March 8, 2024

RE: Status of CU 24-02, DR 24-02, PP 24-01, & SA 24-01 "US Market gas station" at 2540 & 2600 Newberg Hwy (Tax Lots 052W12DB03600 [primary] & 3700)

Staff reviewed the degree of completion of the Conditional Use (CU) consolidated applications package for the subject property with materials submitted February 8, 2024 and determined it incomplete as of March 8, 2024. Staff sends this letter to demonstrate compliance with Oregon Revised Statutes (ORS) [227.178\(2\)](#).

**A1.1a**

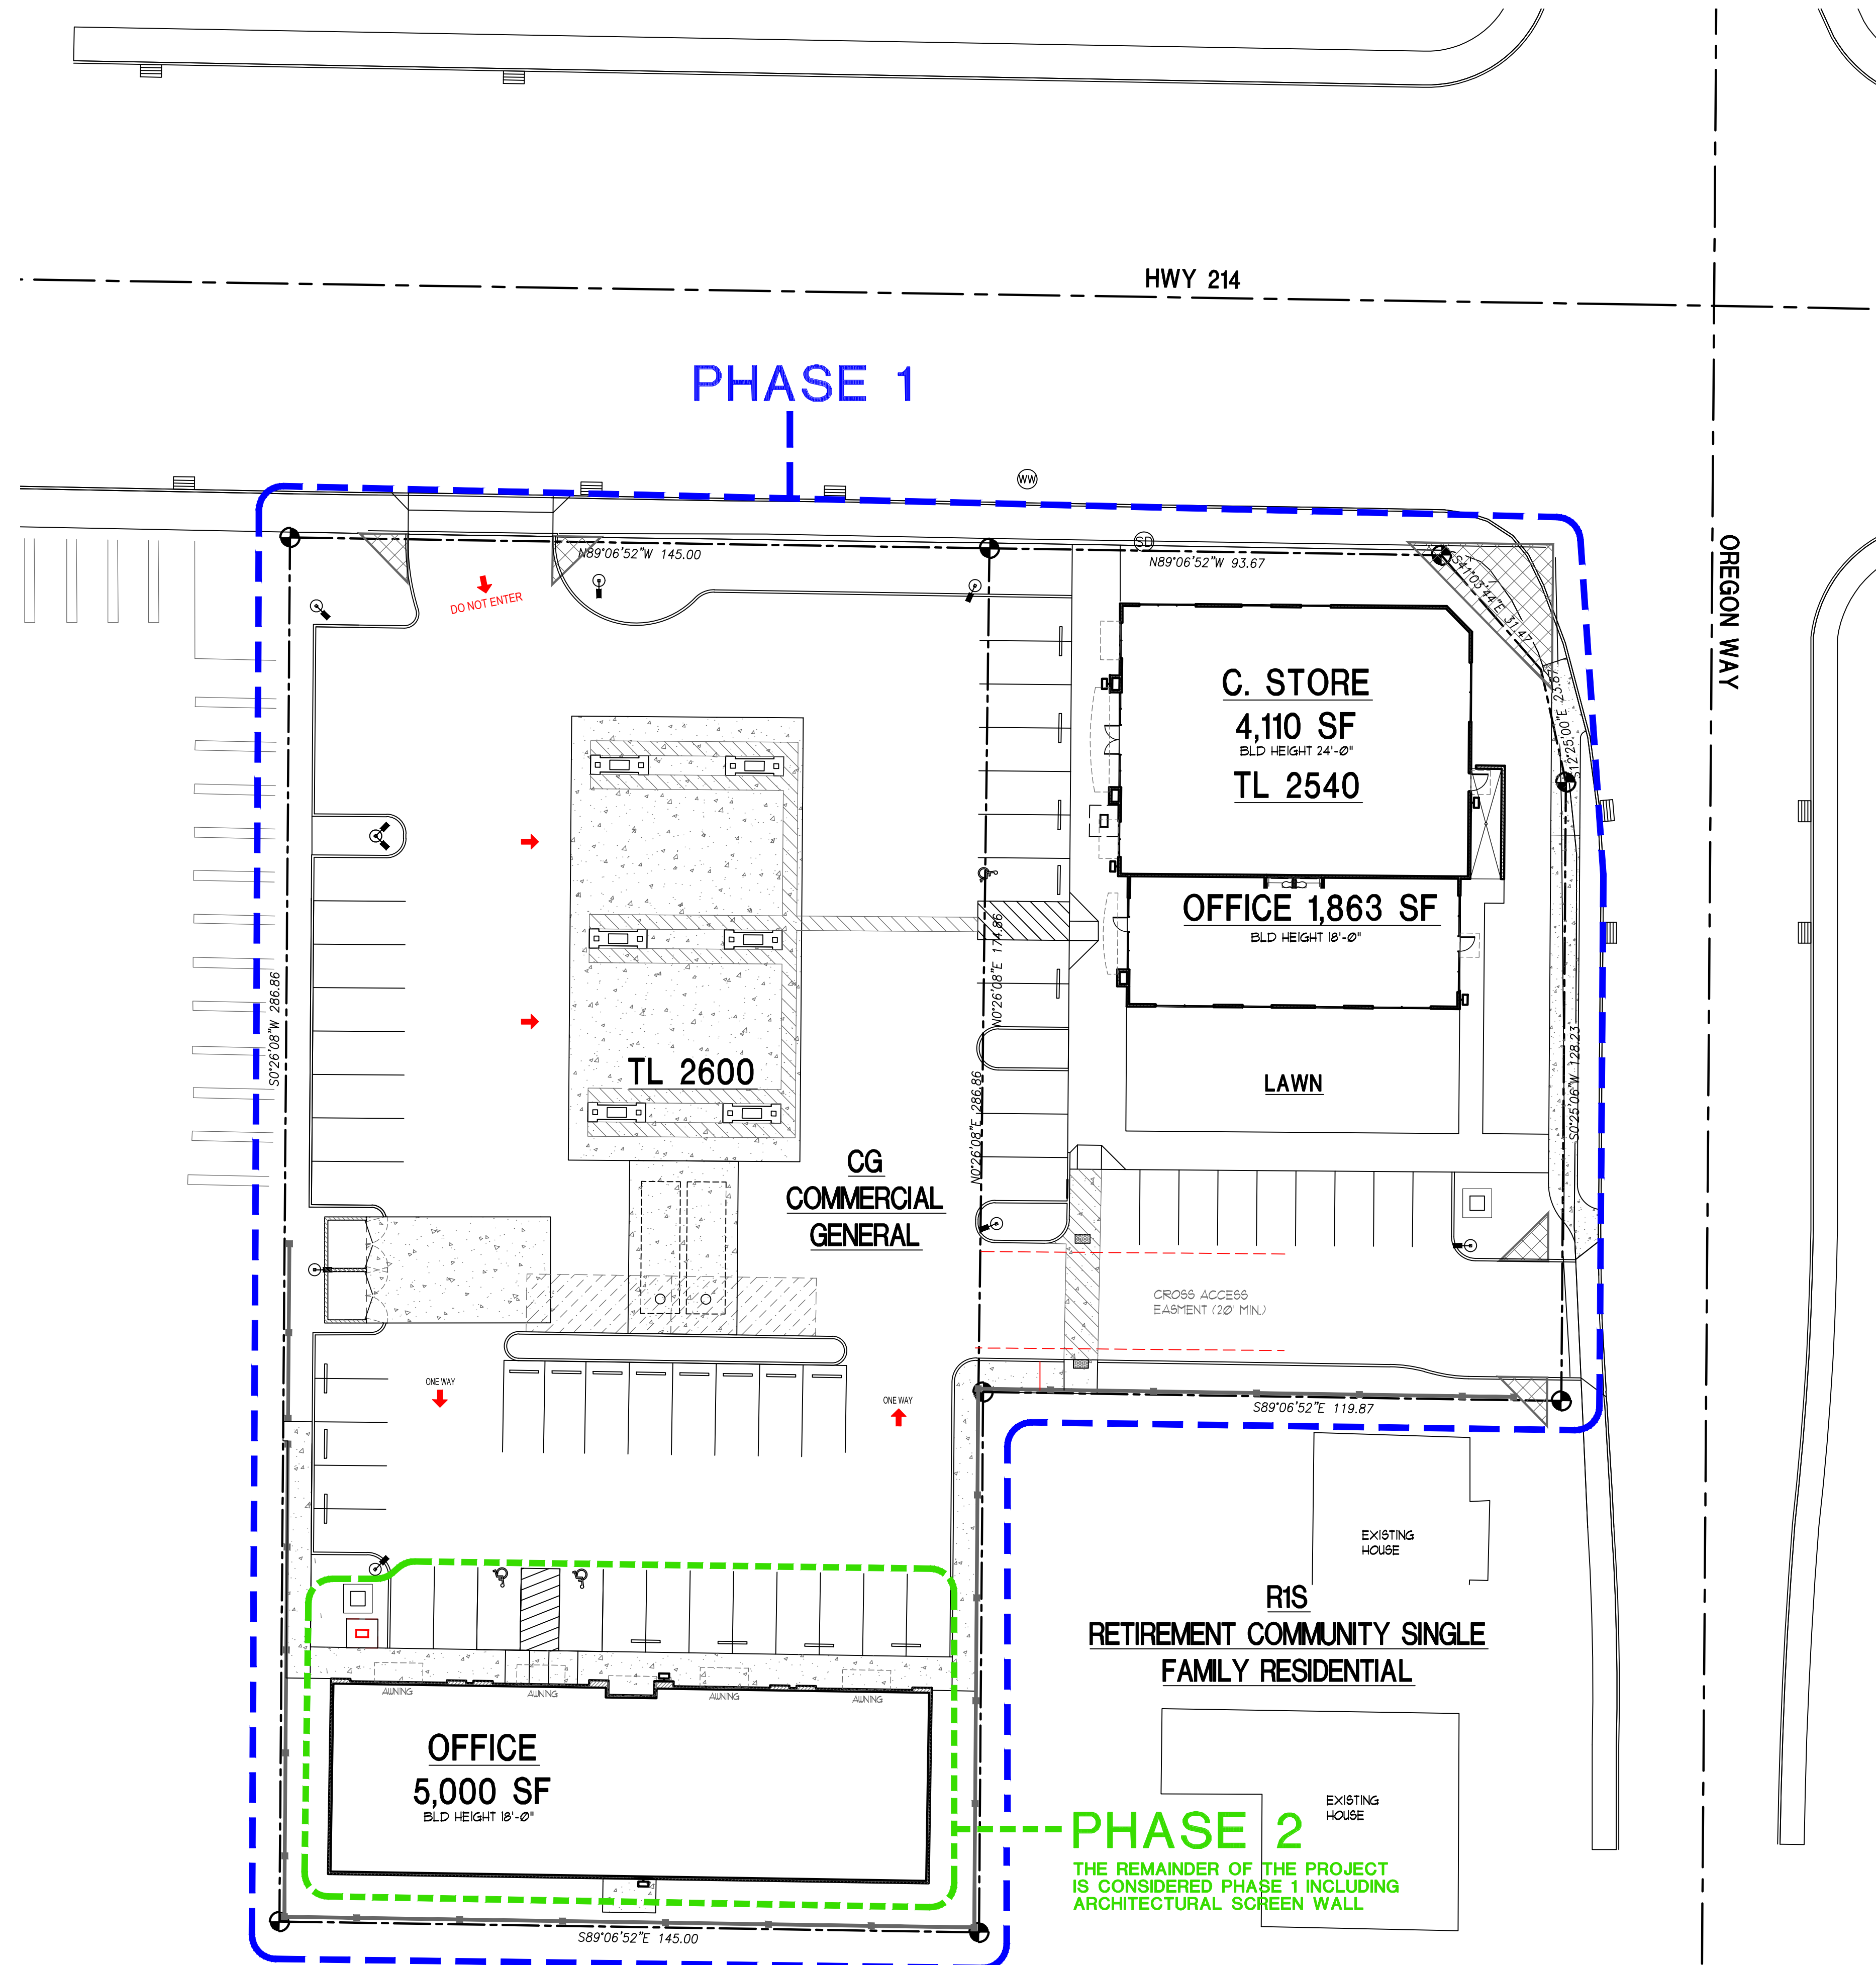
- P. Phasing plan: Revise the phasing plan to address substantively the criteria. Also explain the number, locations, and timing of phases and refer to plan Sheet A1.1a that delineates phase boundaries.

**LANDSCAPE PLAN**  
 SCALE: 1" = 20'  
 H:\0218\TEUK\05\LANDSCAPE\021850 LANDSCAPE PLAN

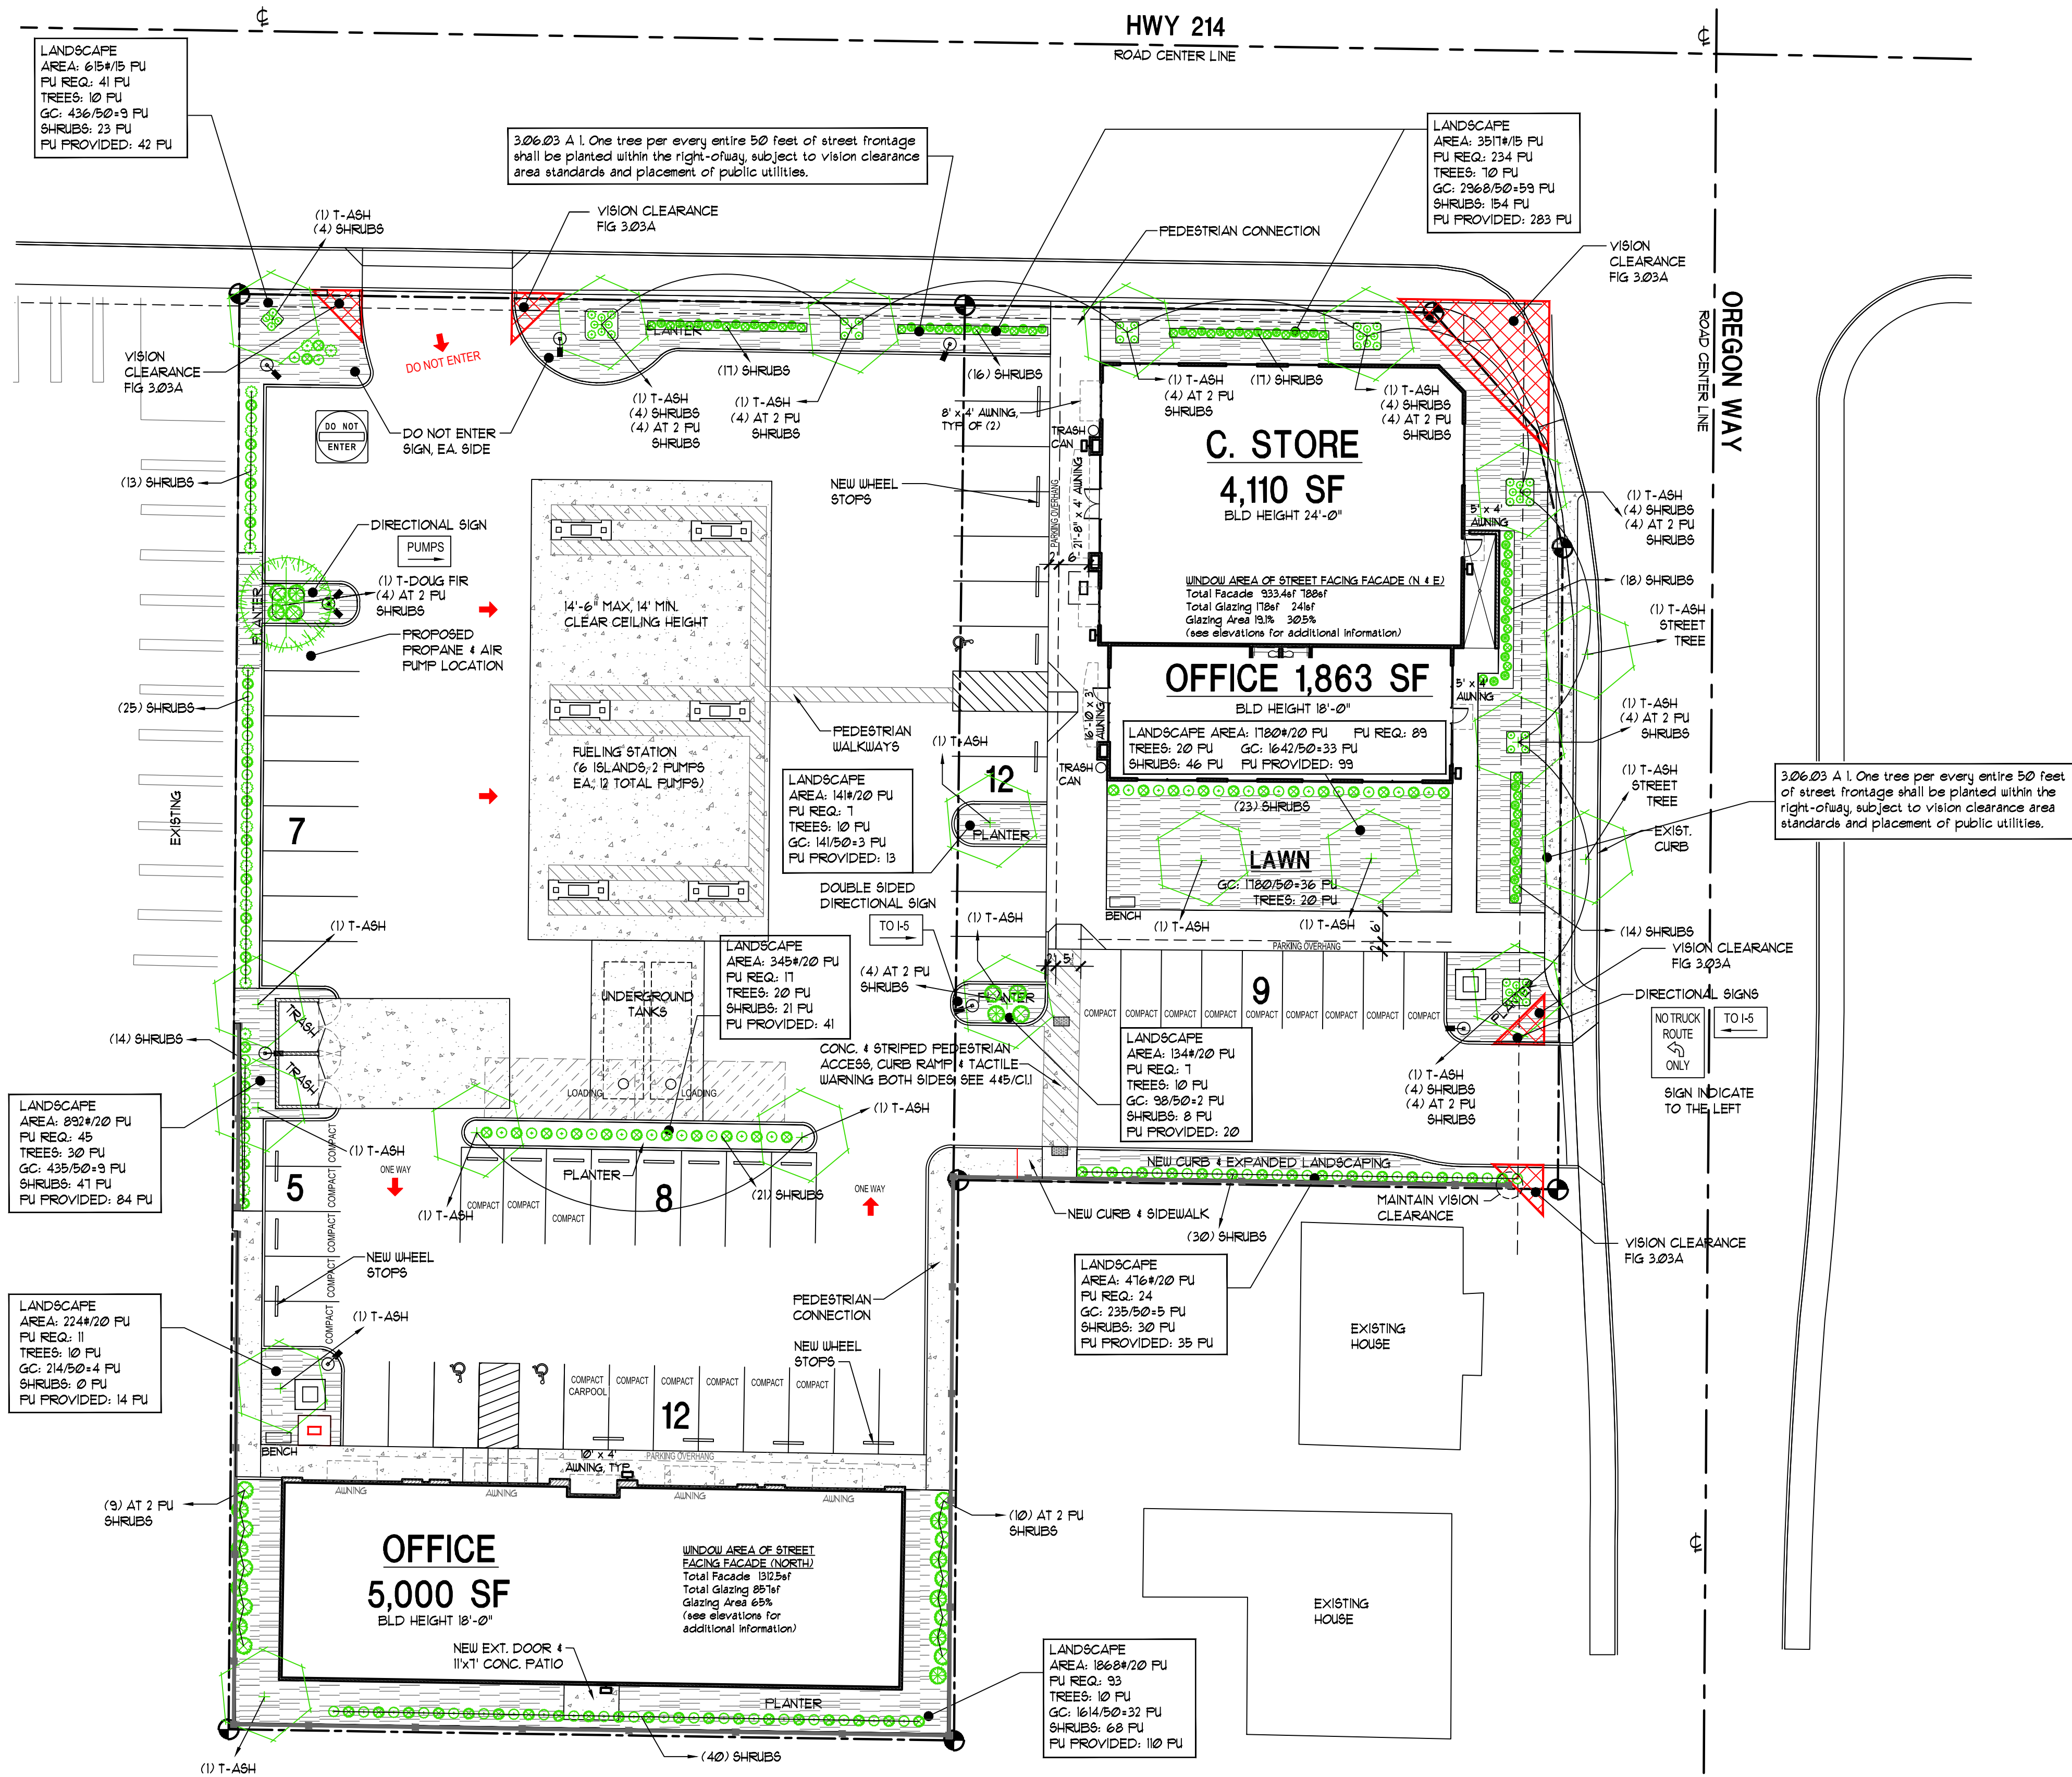
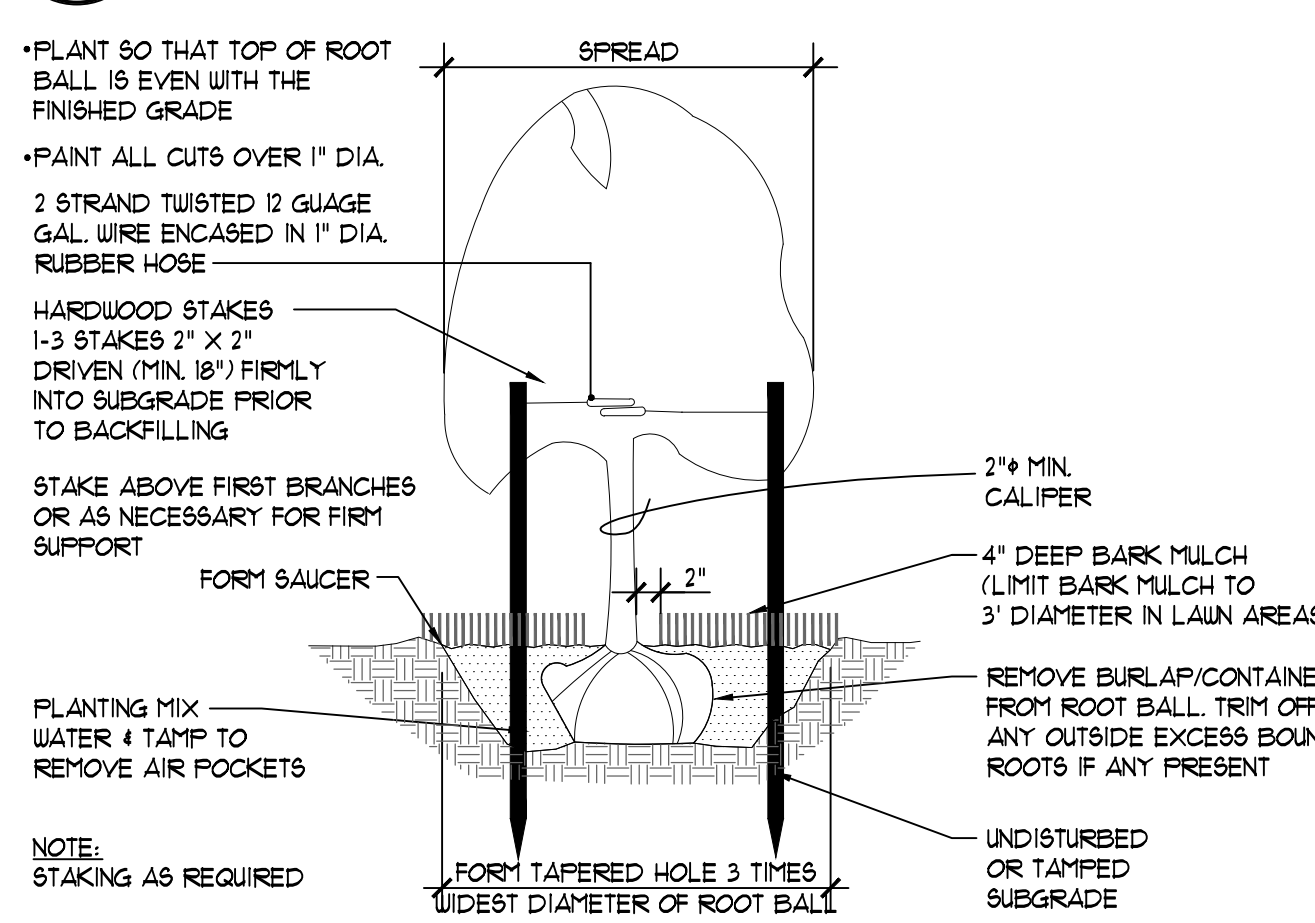
3. The landscape plan illustrates street trees, Raywood ash species, that the legend indicates as size, “7-8’ large”, the “large” presumably based on the size categories at maturity per WDO Table 3.06B. 3.06.03A.2 requires that Access Streets have medium size trees. Revise accordingly.

4. Revise the landscape plan legend to note for each tree species height in feet at maturity.
  5. Landscape strip:
    - a. Revise the call-out note “3.06 ...” to correct from 50 to 30 ft.

- b. Demonstrate that the landscape strip conforms with 3.01.03C.1e as well as the 3.01.04B last paragraph (grass and irrigation) and 3.06.03A.3 about root barriers, be it visually or through further revision of the call-out note.

1. Irrigation: Revise the landscape plan conform with 3.06.02A regarding irrigation and if applicable, subsection B.
2. Parking area landscaped islands/peninsulas: Revise the site and landscape plans to conform with 3.06.03C, particularly for the two parking aisles between the fuel pumps and the south office building.
